## Arklow Flood Relief Scheme

Response to Submissions relating to  
Planning & Environmental Matters  
(ABP ref 301368-21 & 310377-21)

D5246

Issue | 12 January 2022

Date: 20.04.18	Scale: 1/50	Drawn: NM	Chk: KT	App: KT
Project No: PH00886/01	Drw. No: 1046	Rev: P5

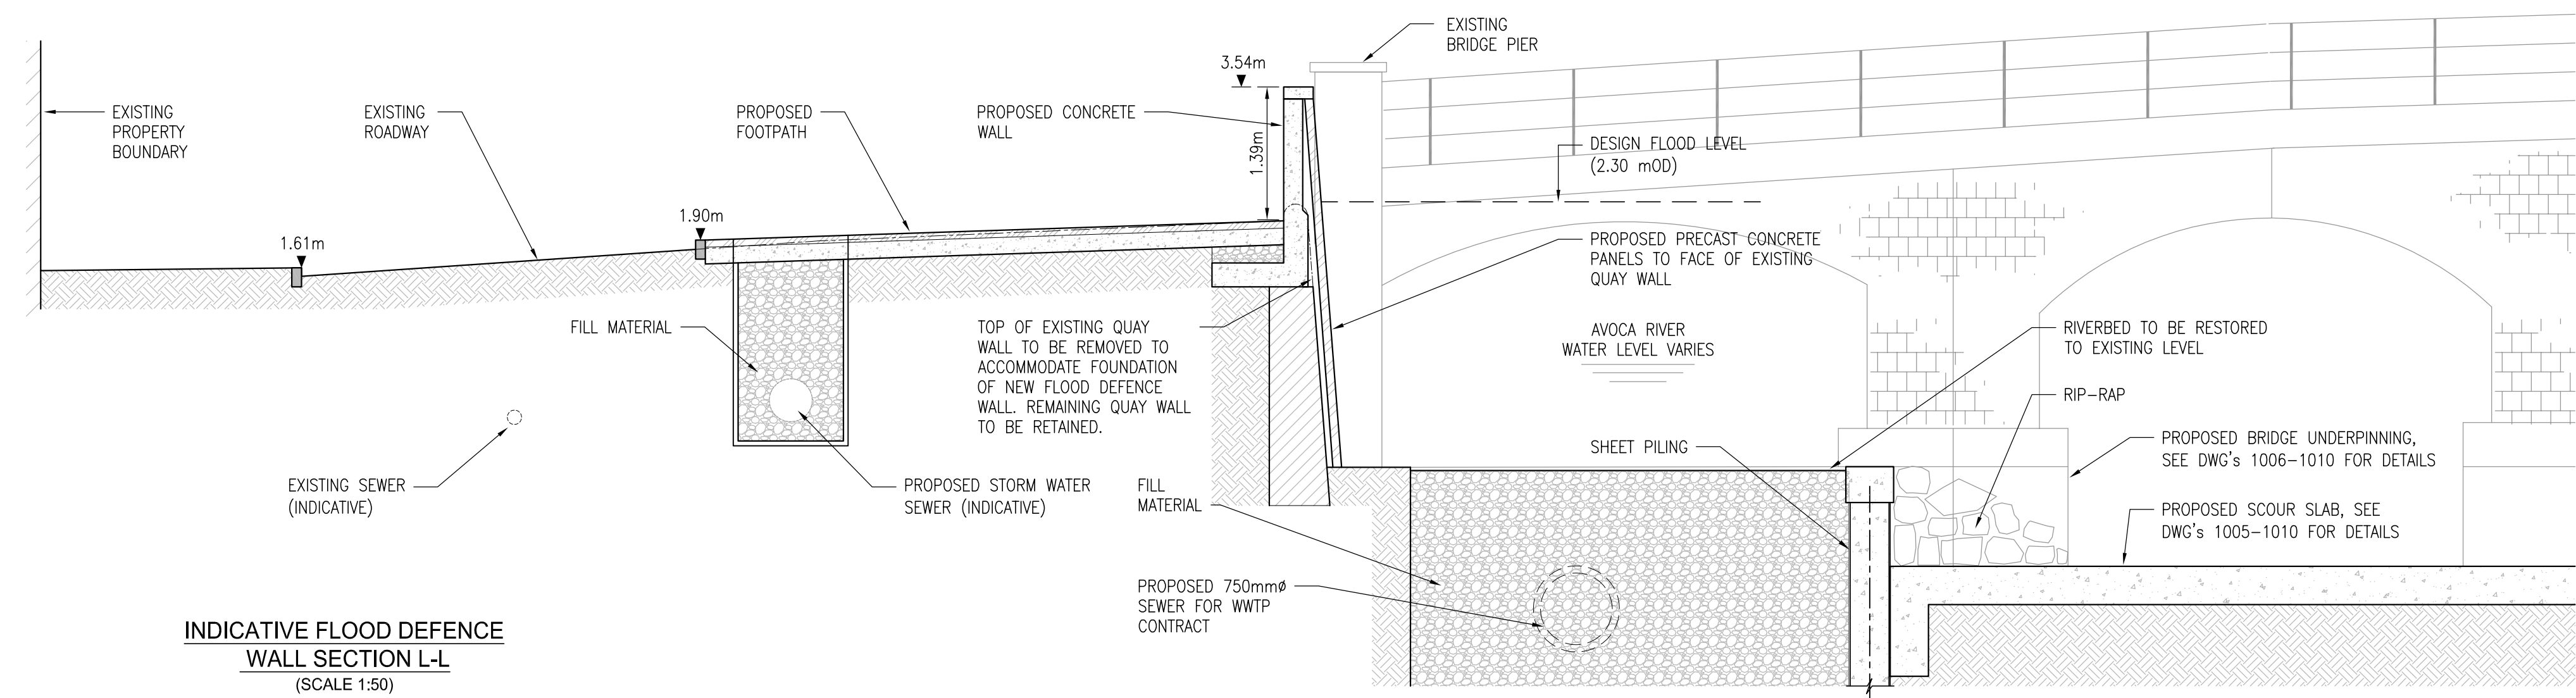
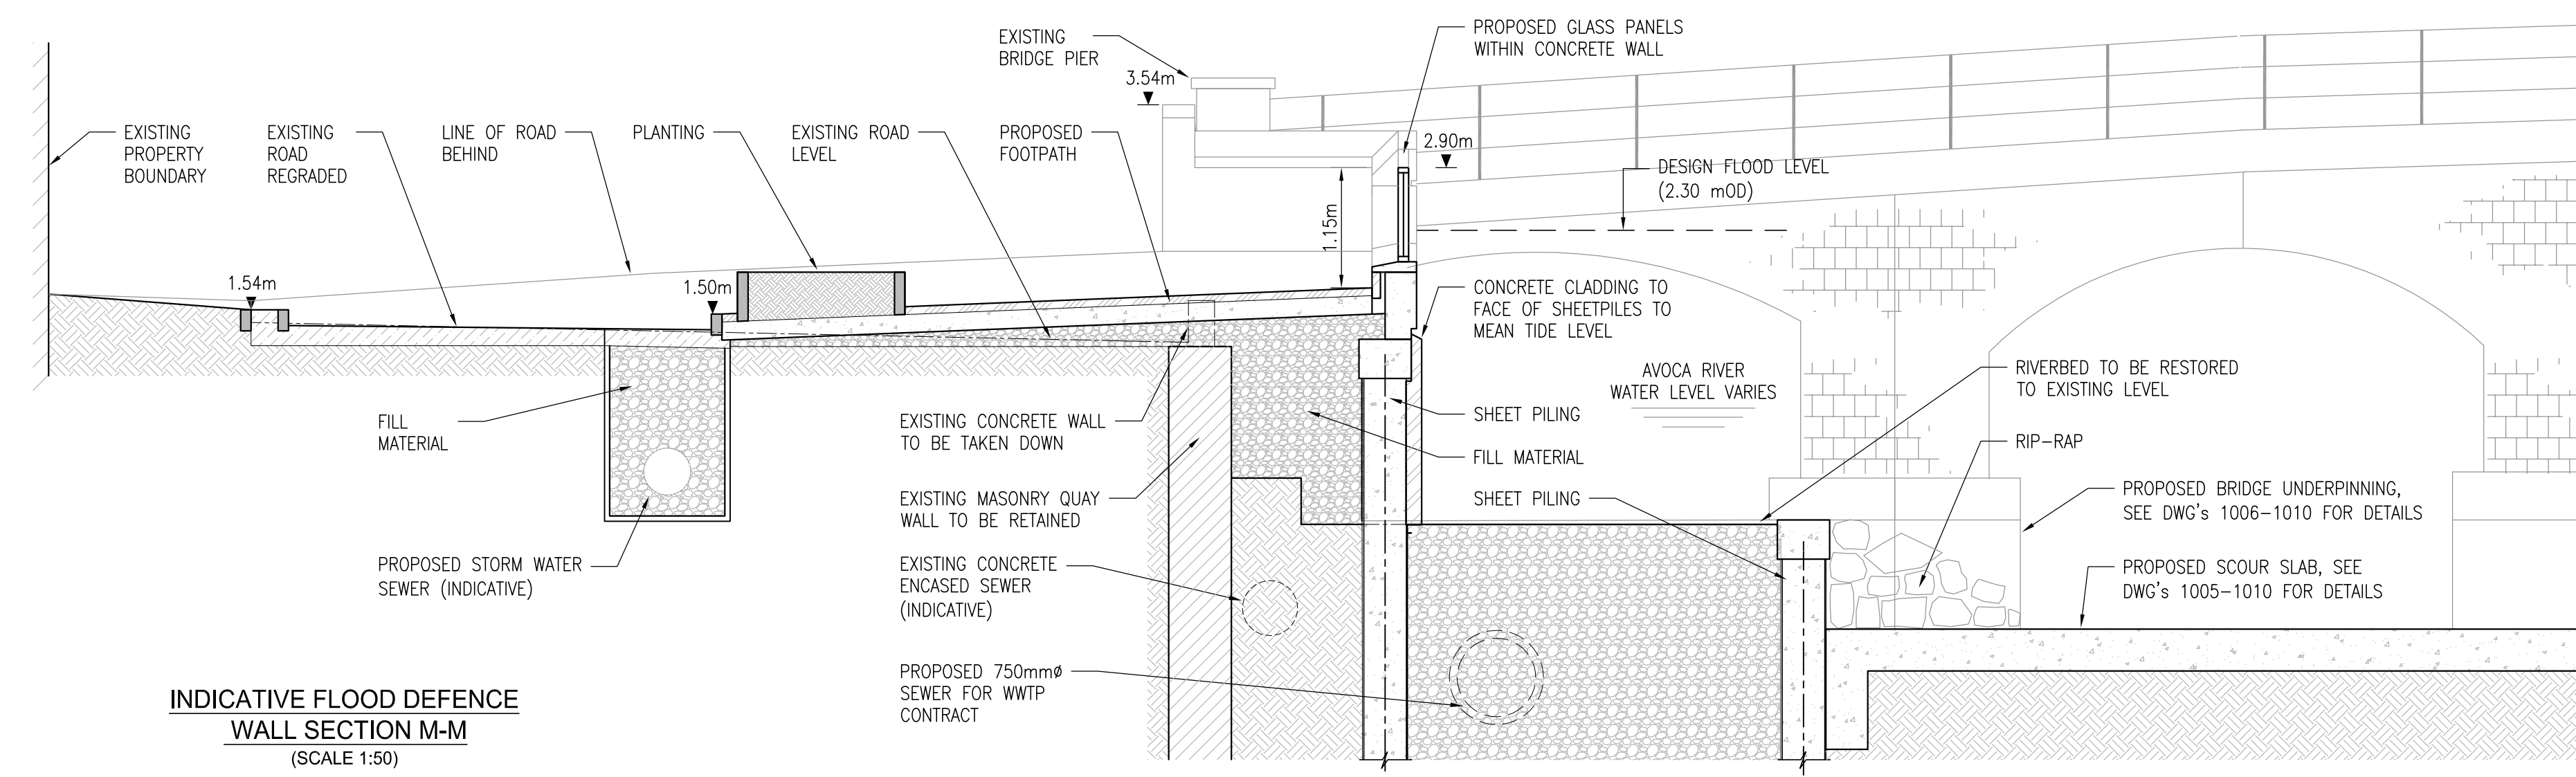
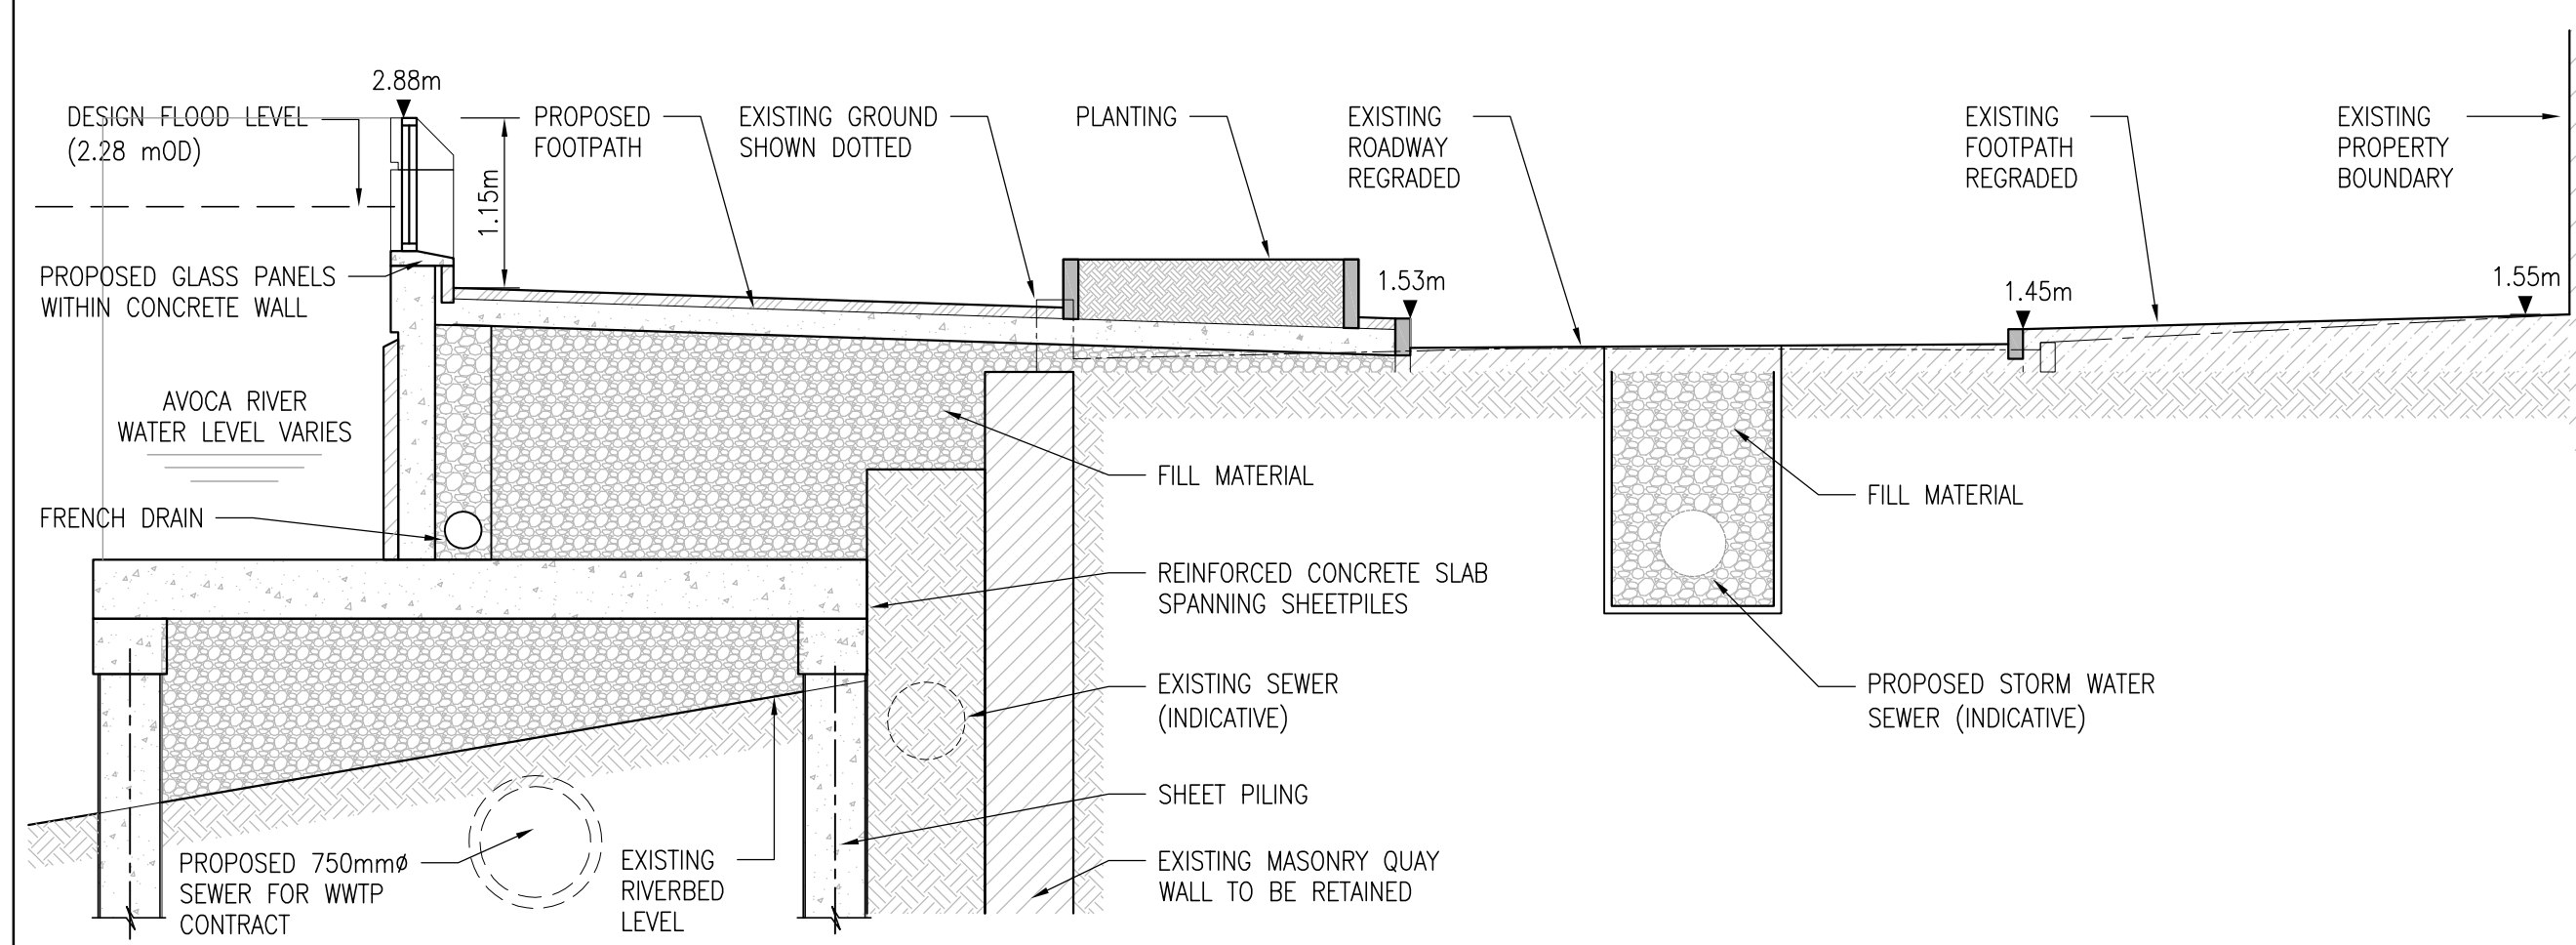
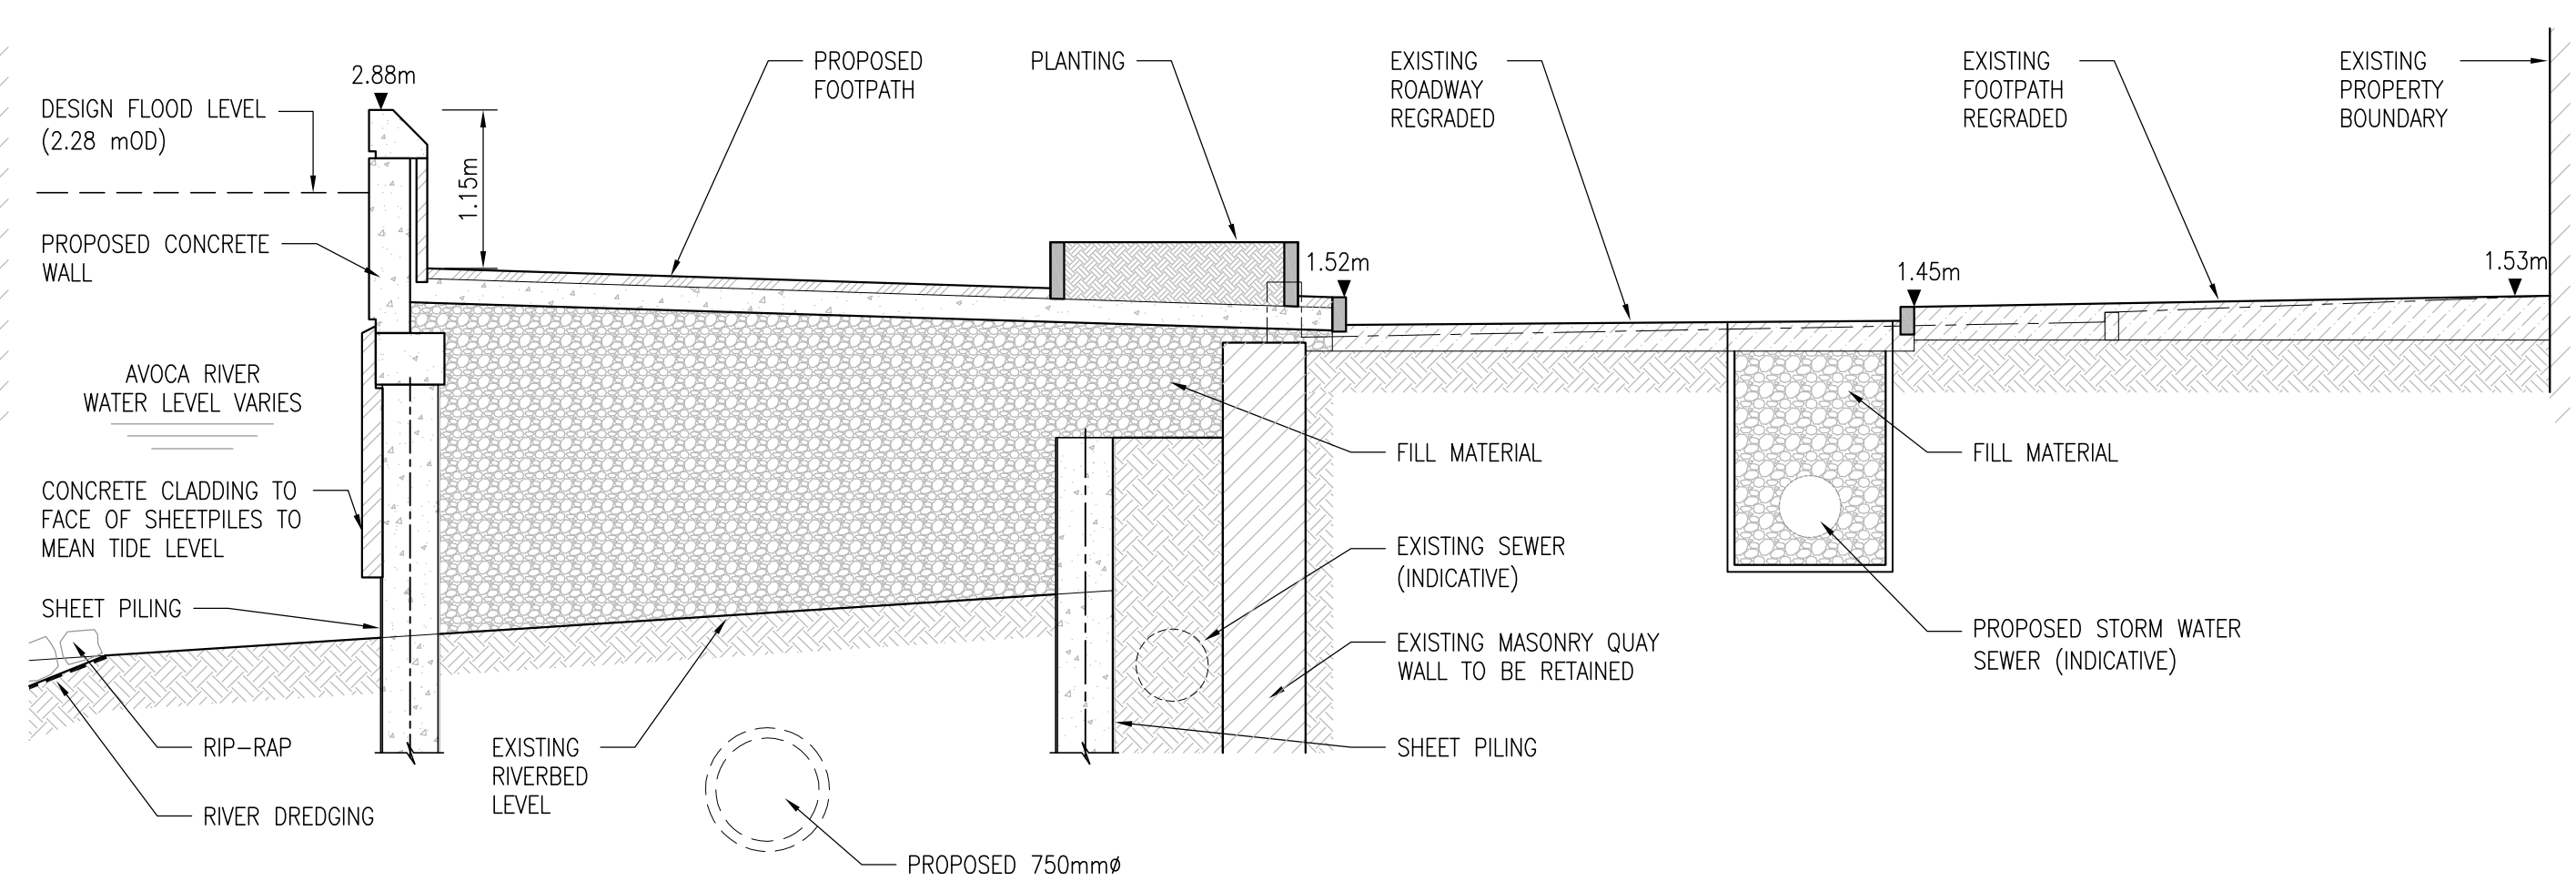
In response to the submissions/objections received by ABP, it is now proposed to include an additional 30.0m of glazing at the following locations listed below. Drawing Nos 1036-1042 and 1046 of Appendix 4.1 (*Scheme Drawings*) and Drawing Nos 301-302 of Appendix 4.2 (*Landscape Design and Public Realm Drawings*) of the EIAR have been revised to reflect these changes and are included in **Appendix A** of this report.

- Addition of two 6.0m long glass panels just downstream of Arklow Bridge on South Quay at approximately Ch 020 (12.0m total), as shown on revised Scheme Drawing No 1040 and revised Landscape Design and Public Realm Drawing No 301 in **Appendix A** of this report. This will open up views of the bridge downstream.
- Addition of three 6.0m long glass panels along South Quay at approximately Chainage 370 (18.0m total), as shown on revised Scheme Drawing No 1041 and revised Landscape Design and Public Realm Drawing No 302 in **Appendix A** of this report.
